#64-F-217C

C.N.R. SUBWAY

FOUNDATION INVESTIGATION REPORT BY:  
Warnock Hersey Soil Investigations Ltd.  
For Canadian National Railways, Toronto.  
Reconstruction of Hwy. No. 11 Subway  
near Eastwood, Ontario, Mile +.9, Dundas  
Sub-Division. (D.H.C. District No. 2)

FOUNDATION INVESTIGATION REPORT BY:  
Warnock Hersey Soil Investigations Ltd.  
For Canadian National Railways, Toronto.  
Reconstruction of Hwy. No. 53 Subway  
near Eastwood, Ontario, Mile 44.9, Dundas  
Sub-Division. (D.H.O. District No. 2)

Client Canadian National Order Number S-64-45  
 Railways Highway #53 Subway near Eastwood Borehole Number 1  
 Ontario, Mile 44.9 Dundas S/D. Date Feb. 16 & 17, 1964.

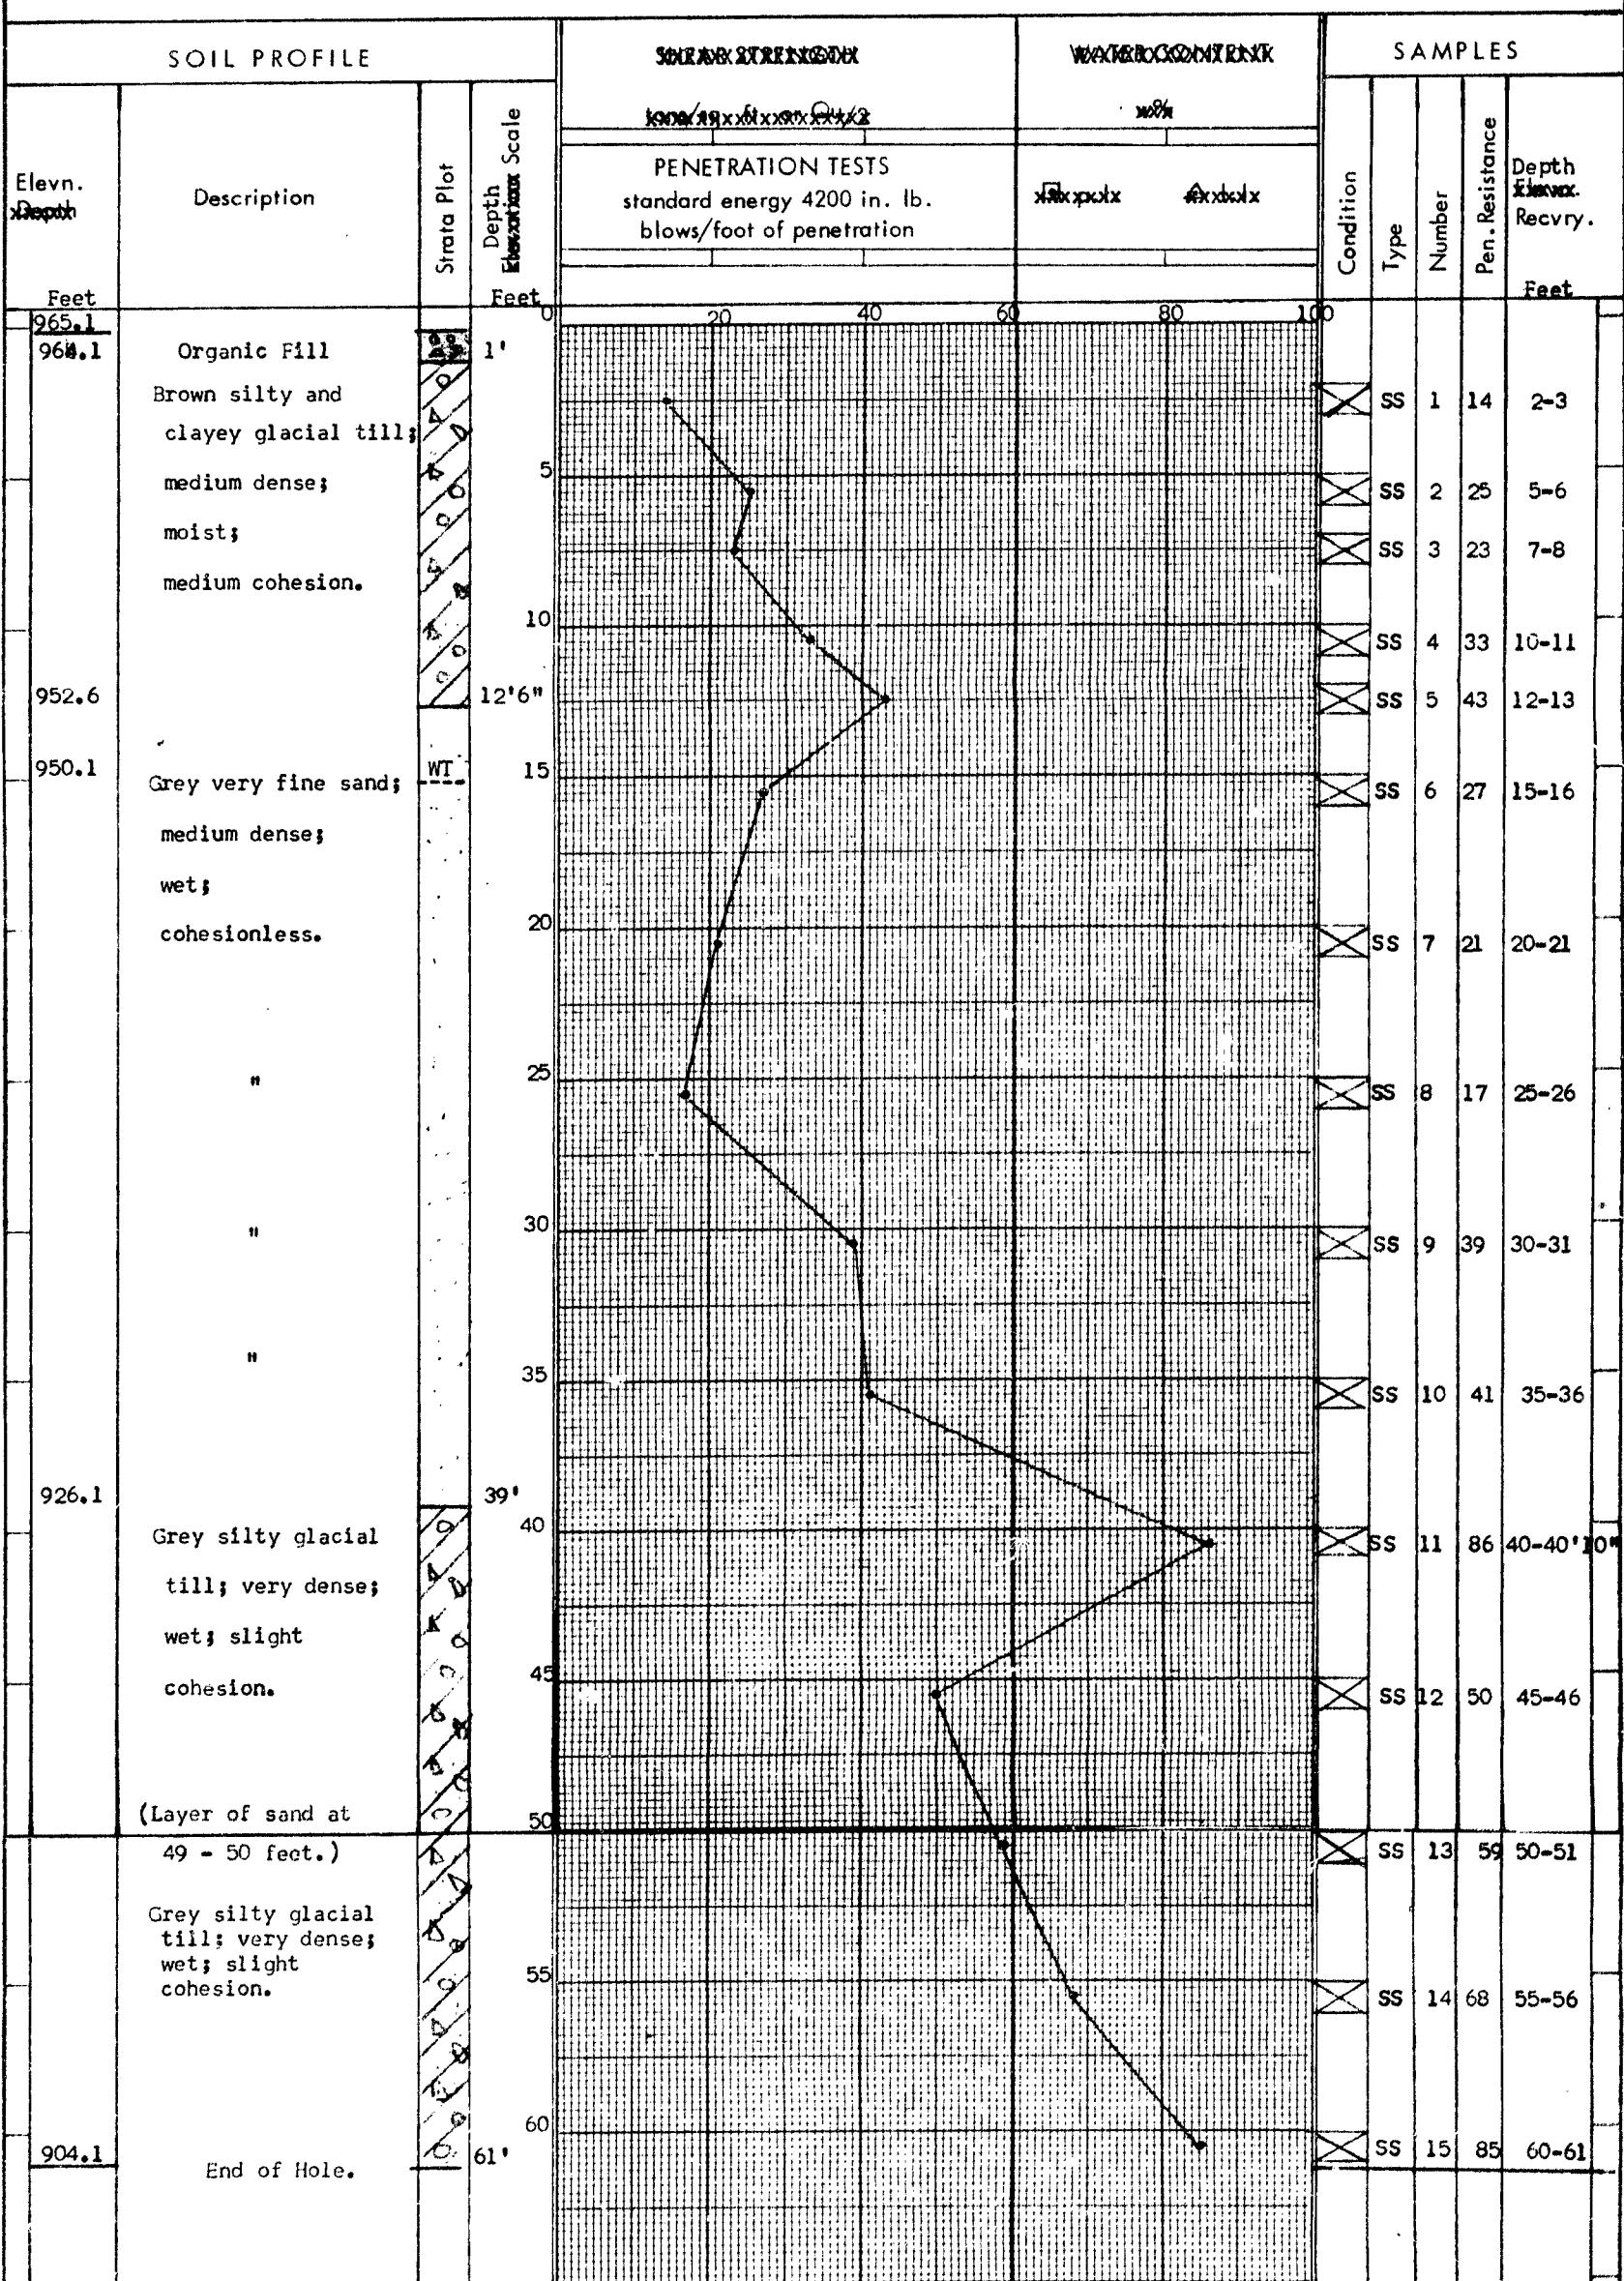
B.H. # 1

945.0

N = 20

(fine sand)

However N values in B.H. # 1 in sand may be corrected according to Gibbs & Holtz — 3 + s.f. may be safe. Elsewhere 3 + s.f. can be used — Even in the vicinity of B.H. # 1 the footings may be placed slightly lower — Pillar nonsense.

The Consultant has suggested using piles for the foundation of the structure. However, the approach used by the Consultant to arrive at this recommendation is rather unconventional and conservative. It is our opinion that spread footings may be used with a design load of 3 T.S.F. at the proposed elevation of 945.0.
